<b>Title-Sujet</b> RCMP B Block Redevelopment		
<b>Solicitation No. – No. de l'invitation</b> 201405073	<b>Amend. – Modif.</b> No. : 3	<b>Date</b> March 17, 2014
<b>Client Reference No. - No. de Référence du Client</b> 201405073		
<b>GETS Reference No. – No de Référence du SEAG</b> 201405073		
<b>Solicitation Closes – L'invitation prend fin</b> <b>at - à 2 :00 pm EST</b> <b>on - le March 24th, 2014</b>		
<b>F.O.B. - F.A.B.</b> Destination		
<b>Address Enquiries to: - Adresser toute questions à :</b> Eric Glynn – Manager - Procurement		
<b>Telephone No. - No de téléphone</b> 613-843-5533	<b>Fax:</b> 613-825-0082	
<b>Destination of Goods - Destinations des biens:</b> See Herein		
<b>Instructions : See Herein / Voir aux présentes</b>		
<b>Delivery Required – Livraison exigée:</b> See Herein		
<b>Name and Title of person authorized to sign on behalf of Vendor/Firm.</b> <b>Nom et titre de la personne autorisée à signer au nom du fournisseur/de l'entrepreneur</b>

Amendment #3 of Solicitation 201405073 has been issued to provide Addendum #2 to the Specifications and Drawings.

**ADDENDUM NUMBER: TWO****ISSUED BY: SEPW Architecture Inc.**  
109 - 3725 Pasqua St., Regina, SK S4S 6W8  
PH.

2  
A7.3  
1:2  
SIGNAGE ELEVATIONS  
(WALL PLATES)

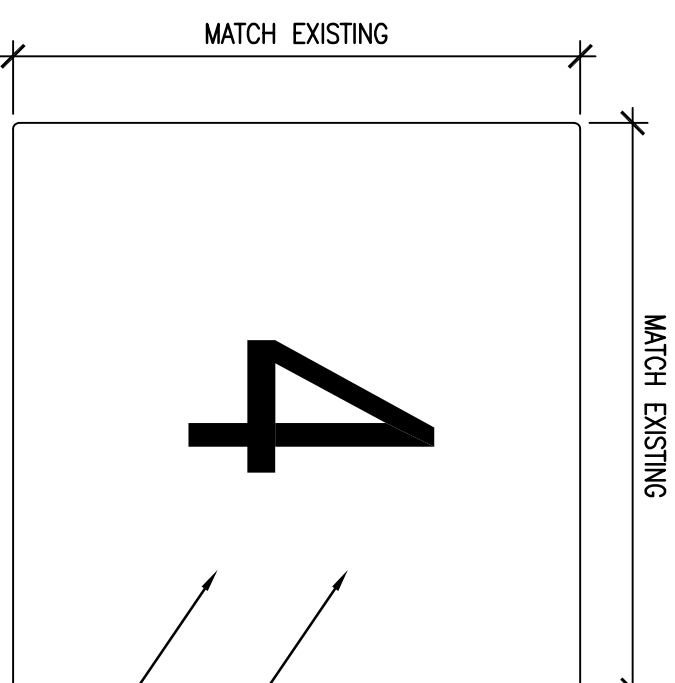
- .1 Reference Drawing 4, Signage Elevations; ADD additional wall plates as indicated on sketch AR18 accompanying this addendum.

MATCH EXISTING COLOURS,  
FONTS AND SIZING

RELOCATE EXISTING FLOOR  
DESIGNATION NUMBERS #1,  
#2 AND #3 TO THE NEWLY  
LABELED FLOORS

DRAWING TITLE  
**ELEVATION AT REMOVED/NEW ELECTRICAL PANEL**

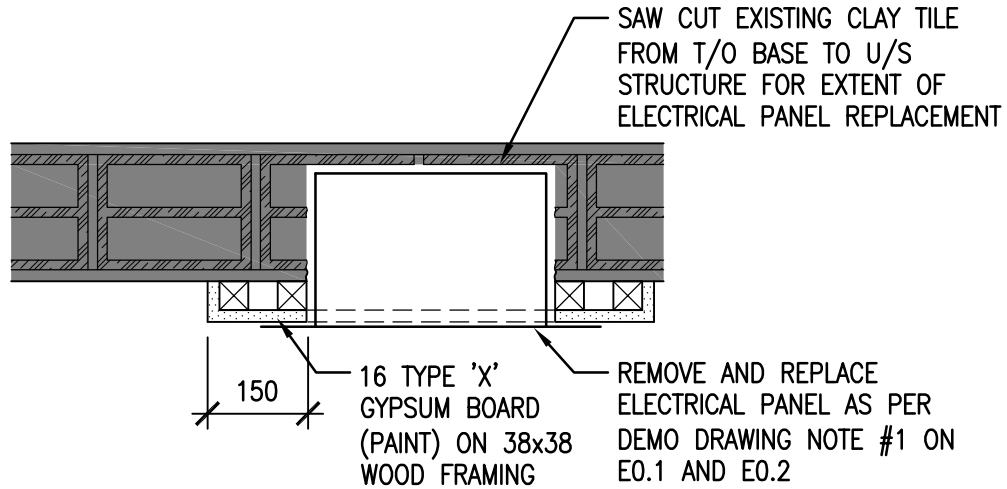
- .1 Refer to Drawings E0.1 and E0.2 at existing electrical panel locations where modified by electrical work. Provide finishes as per AR19 and AR20 to suit conditions.

1 WIREMOLD RACEWAY DETAIL  
E5.2R2 N.T.S.

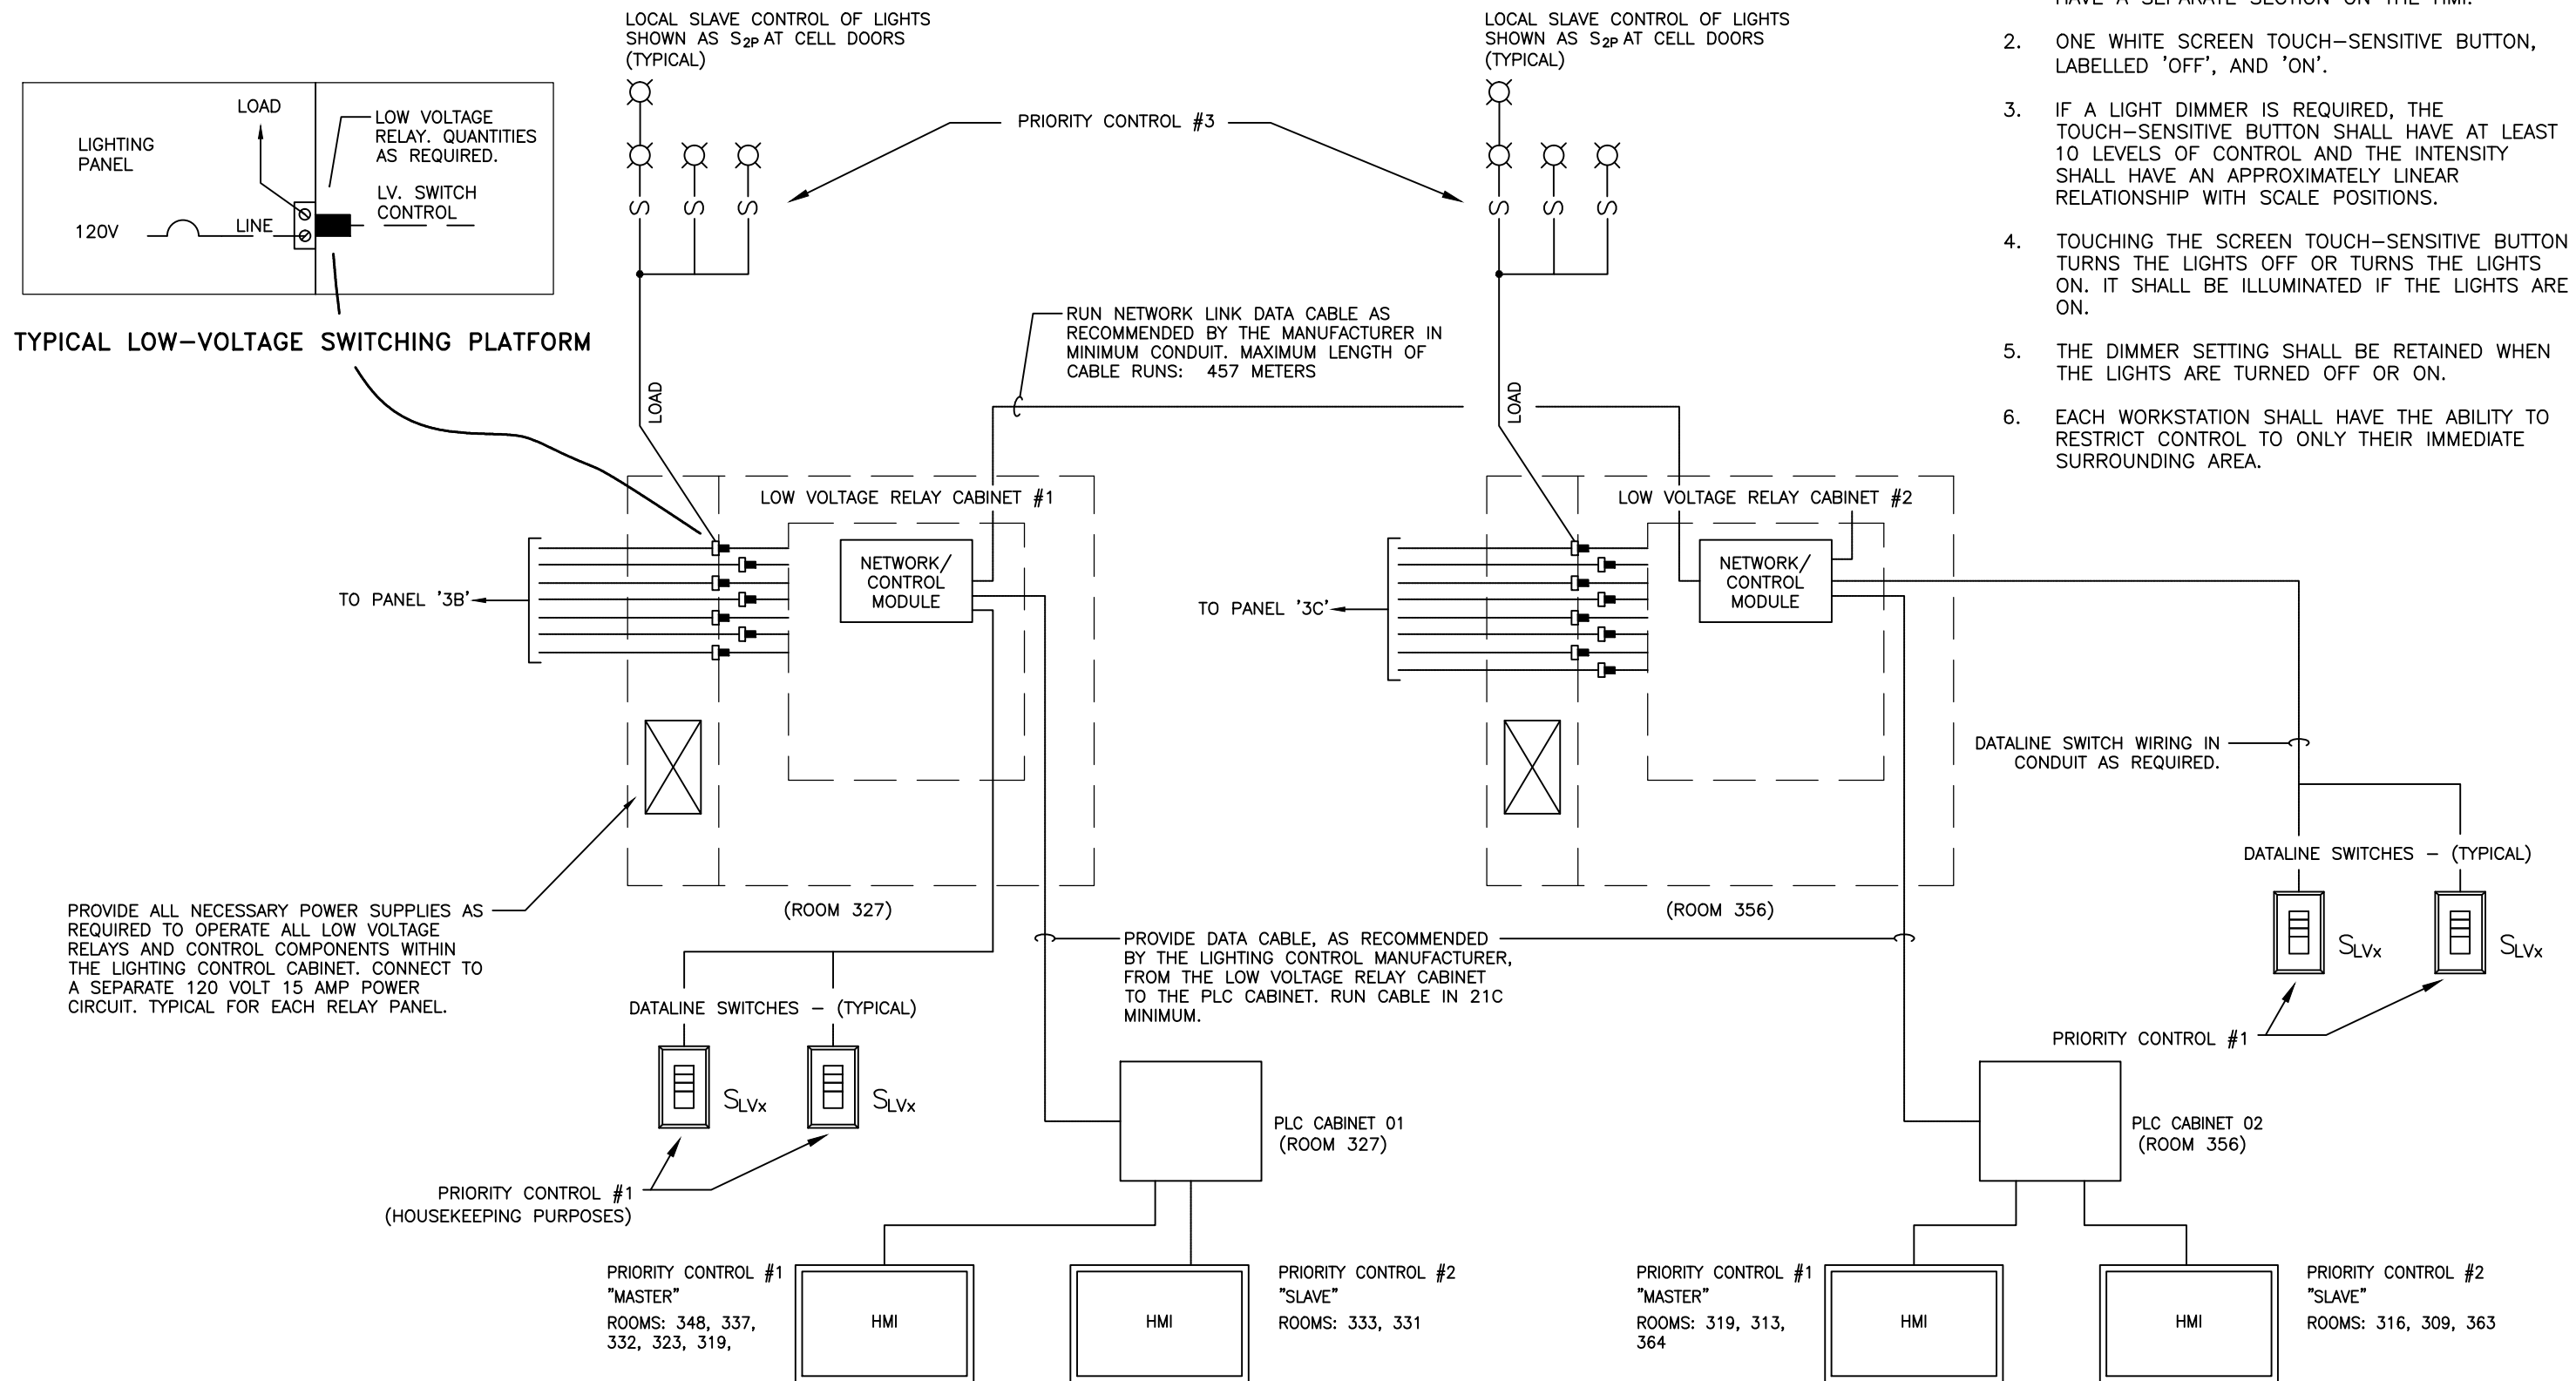
- .1 All vertical and horizontal wiremold raceway shall be of the type shown in sketch E5.2R2 accompanying this addendum.
- .2 All systems and data cabling utilizing basket trays shall be run in conduit in all locations except for transition to basket tray. The use of J-hooks, brackets, cable ties, and other attachments to support cabling is not acceptable.

RACEWAY SHALL BE TWO-COMPARTMENT, SINGLE-COVER, PVC RACEWAY FITTINGS AND COUPLINGS IN WHITE FINISH. PROVIDE DEVICE OPENINGS TO ACCOMMODATE DUPLEX AND SINGLE RECEPTACLES, AND DATA/VOICE JACKS AS INDICATED ON DRAWINGS.

ALL FIELD CUTS SHALL BE SANDED OR FILED TO REMOVE ALL BURRS AND PROVIDE A SMOOTH SURFACE. JOINTS BETWEEN THE RACEWAY AND THE WALL SHALL BE CAULKED. DATA/VOICE CONDUIT SHALL BE STUBBED INTO THE ACCESSIBLE CEILING SPACE.

**1 FIRST FLOOR PLAN**  
 E6.1  
 1:100

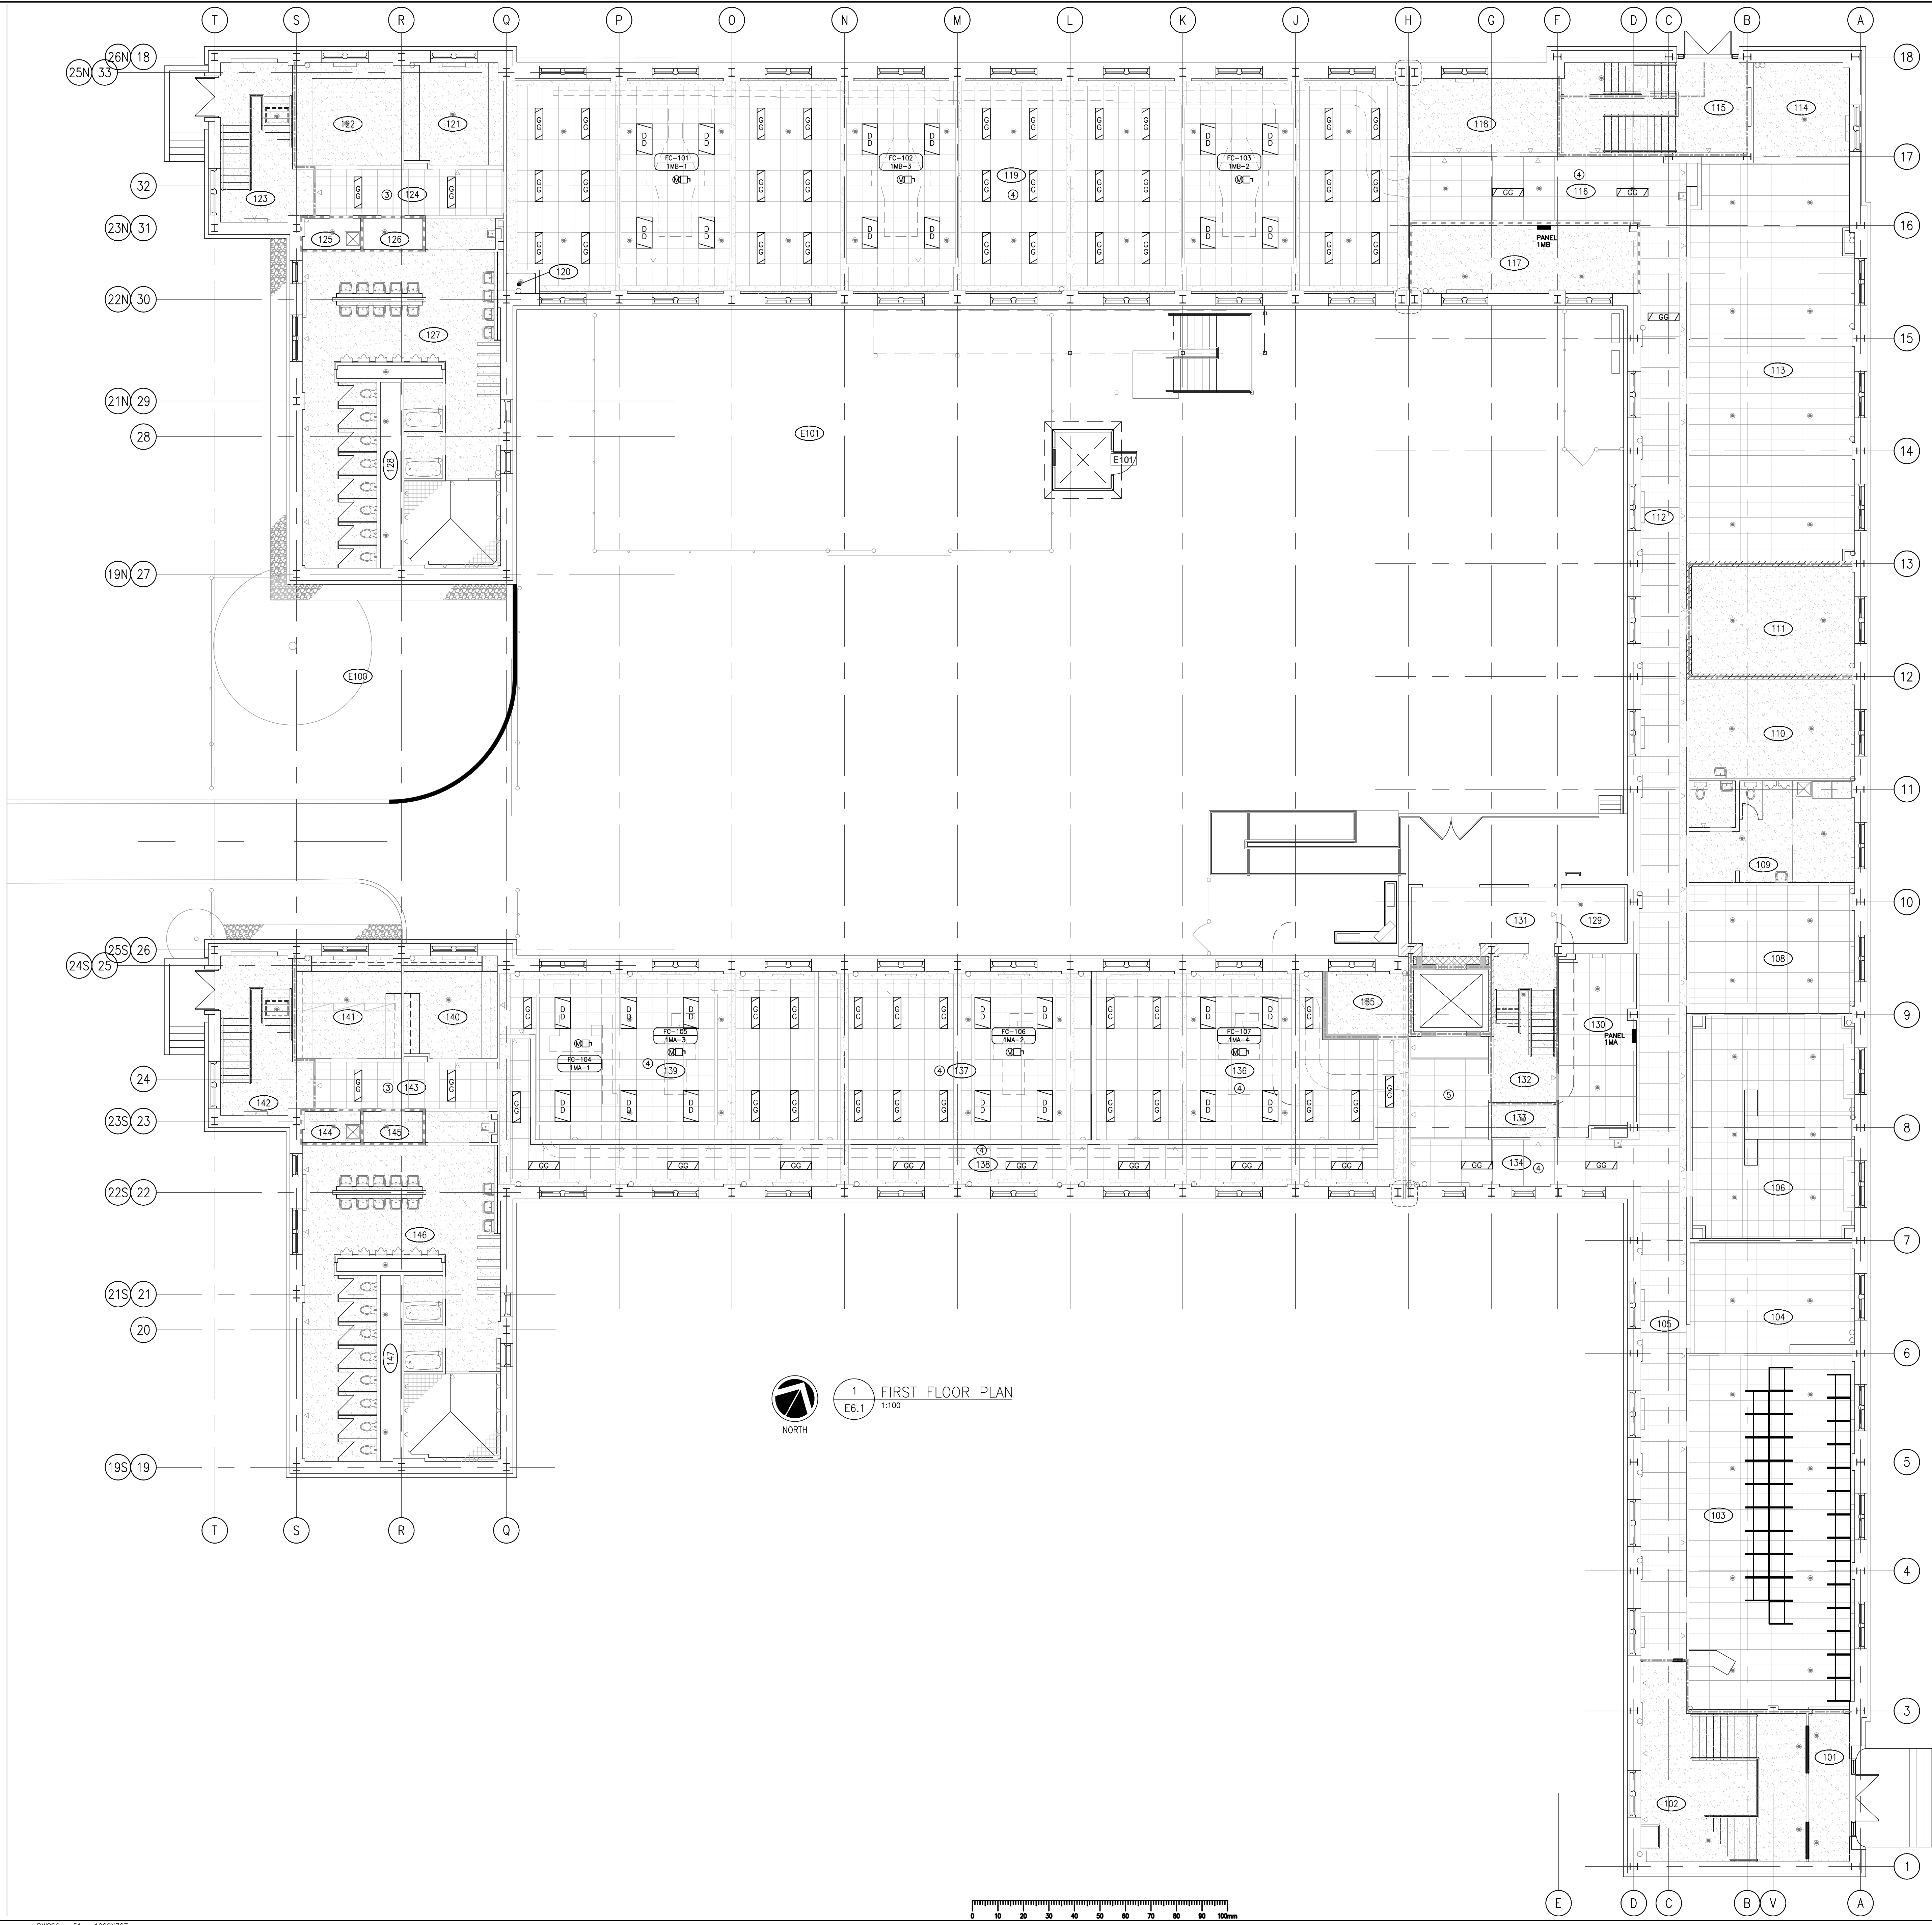
- .2 Add drawings E6.1 and E6.2. These drawings detail new lighting plans and mechanical connections for floors 1 and 2.

- .1 ADD Drawing E6.1, First Floor Lighting/Power Plan, accompanying this addendum.
